MCDONALD BUSINESS PARK  
NORTH McDonald STREET & WILMETH ROAD  
CITY OF MCKINNEY, TEXAS 75071

DATE: 10.16.2023  
SHEET NAME: LANDSCAPE PLAN  
SHEET NUMBER: L-3

01 LANDSCAPE PLAN  
SCALE 1"=40'

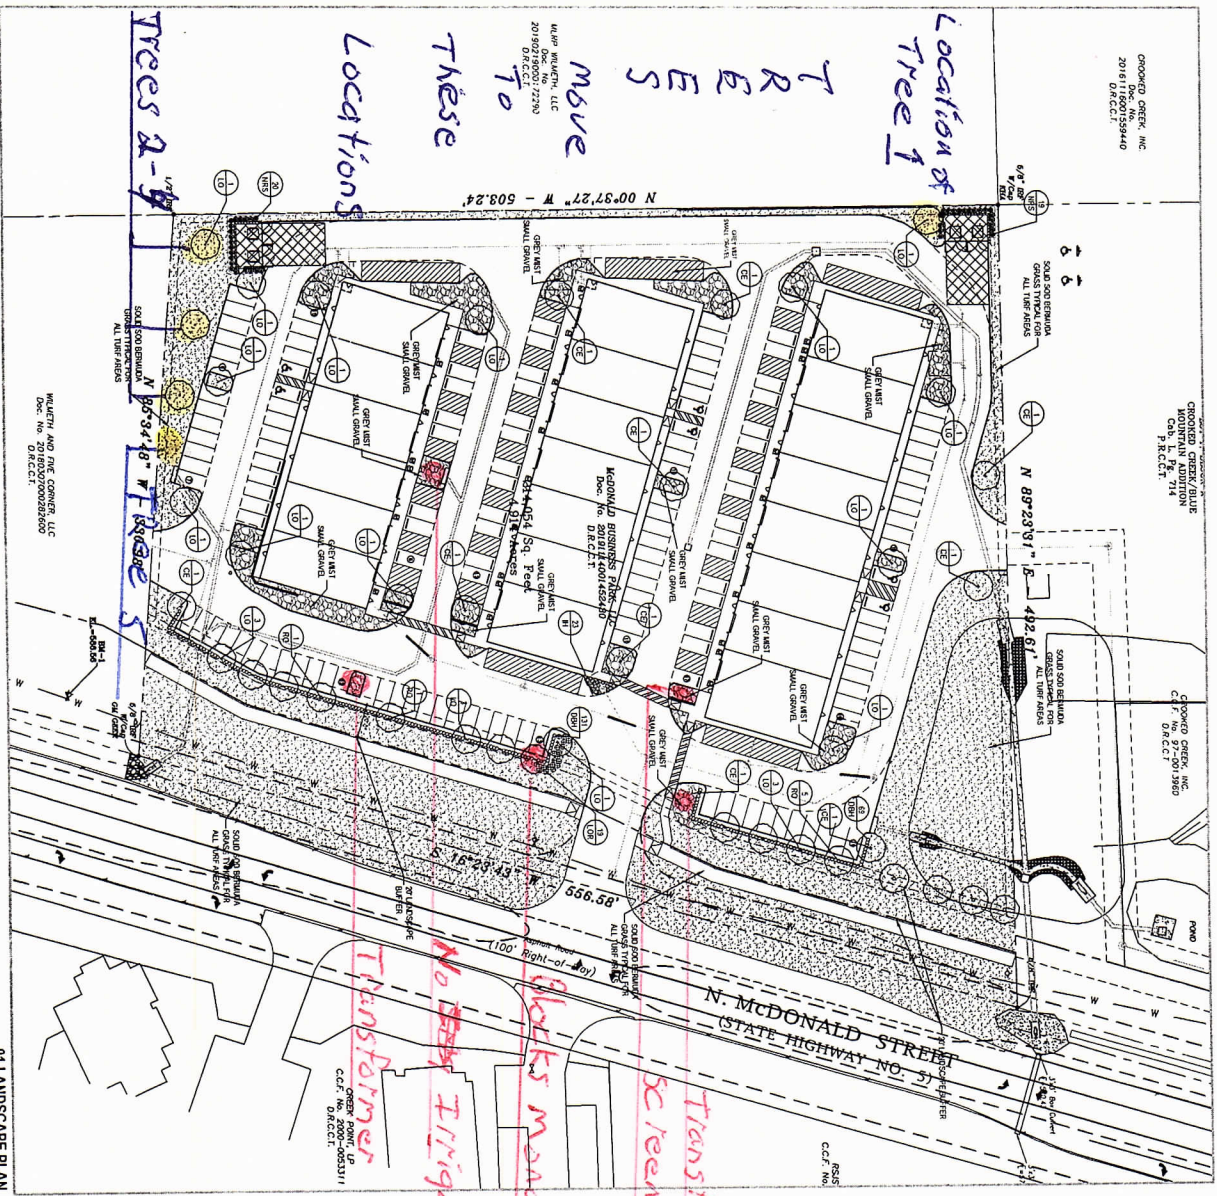
Trees to be removed in Red and the reason why
